NUREG-1556

Consolidated Guidance About Materials Licenses

Program-Specific Guidance About Fixed Gauge Licenses

Final Report

Figure 8.4 Annual Dose Limits for Occupationally Exposed Adults.

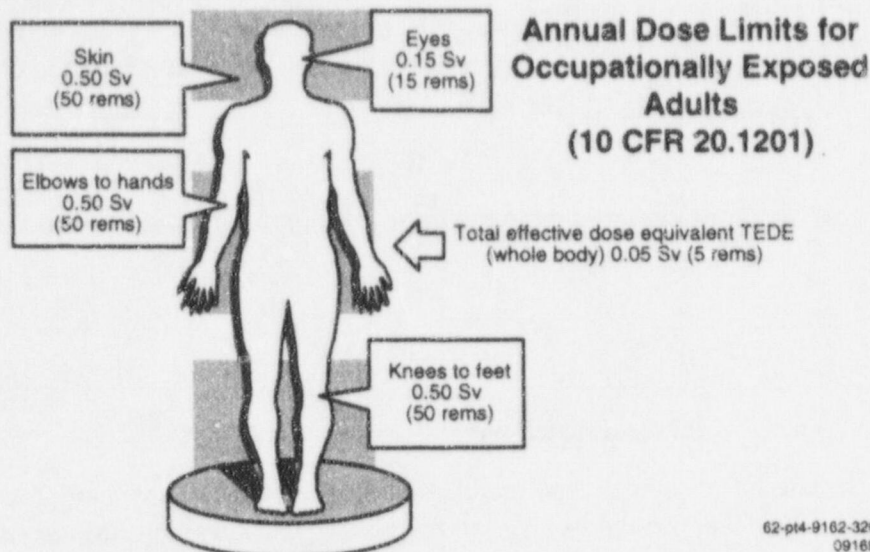
8-18	Figure 8.4	<ul style="list-style-type: none"> • Note LDE (although not named as such) is included here, but not referenced elsewhere. • Missing Internal dose (CEDE & CDE) • Missing DDE
------	------------	--

Figure 8.6 Proper Handling of Incident. Licensee personnel implement emergency procedures when a fire melts the lead shielding of a gauge producing the potential for elevated exposure levels.

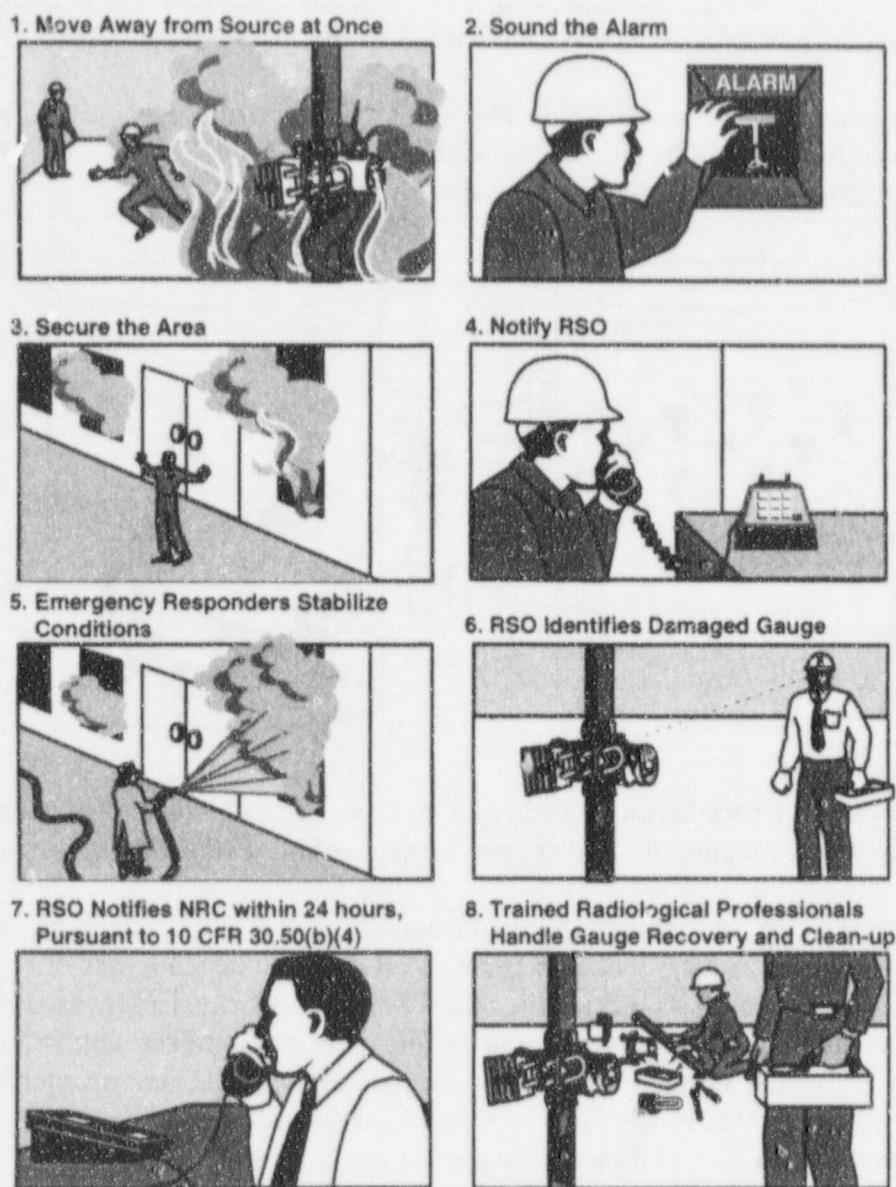
8-24	Figure 8.6	Why do you talk about trained radiological personnel here and ignore their existence and qualifications elsewhere?
------	------------	--

NRC Staff Response: The last illustration (#8) in Figure 8.6, has a caption which states, "Trained Radiological Professional Handle Gauge Recovery and Clean-up." Use of fixed gauges is not typically the primary activity for the vast majority of fixed gauge licensees. Fixed gauge licensees be capable of responding to an emergency situation involving a fixed gauge. This caption is meant to imply that a typical fixed gauge user or RSO may not have the resources or the training and experience to handle the aftermath of a incident where a gauge is damaged, the sealed source may be exposed, and contamination is a possibility. More experienced individuals may need to be consulted to ensure that recovery and clean-up is performed safely.

Figure 8.9 Maintenance. Licensees need to perform routine maintenance to ensure proper operation of the fixed gauge. For non-routine maintenance, most licensees rely on the gauge manufacturer, distributor or other service companies.

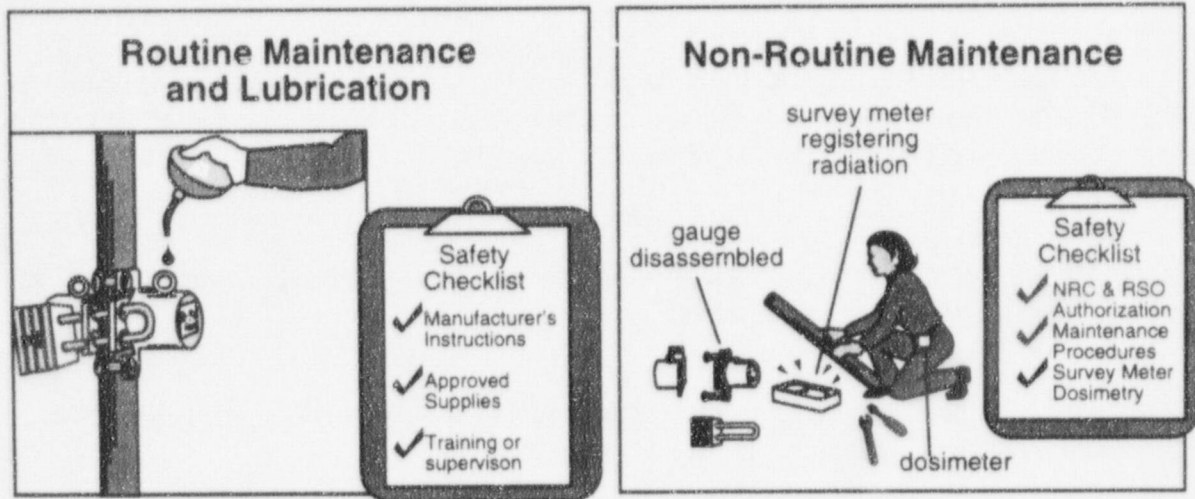
8-29	Figure 8.9	<ul style="list-style-type: none"> • Why does this picture/diagram suggest that NRC authorization is necessary to do non-routine maintenance on the gauge? • We guess that it's intent is to indicate that the person doing the maintenance is authorized by the NRC to do so, but again, how does one obtain this authorization?
------	------------	---

Figure 8.11 Proper Handling of Incident. Licensee personnel implement emergency procedures when a traffic accident results in a damaged gauge and potentially elevated exposure levels.

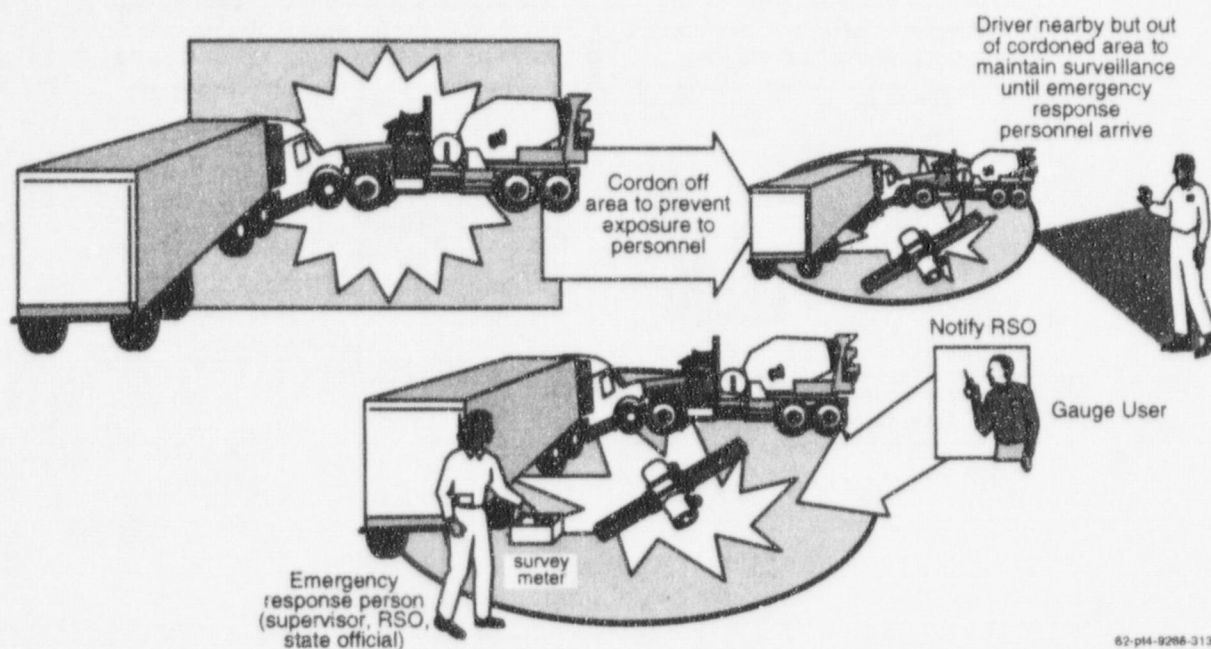
8-33	Figure 8-11	Need to deal with contamination control measures as referenced before.
------	-------------	--

NRC Staff Response: Detailed consideration of control of contaminated objects and personnel is beyond the intended scope of the emergency procedures provided in Appendix L. However, some consideration is given to contamination control in Appendix L in the 2nd and 3rd bullets under Emergency Procedures. See also response to comments regarding figure 8.6 on page 8-24.
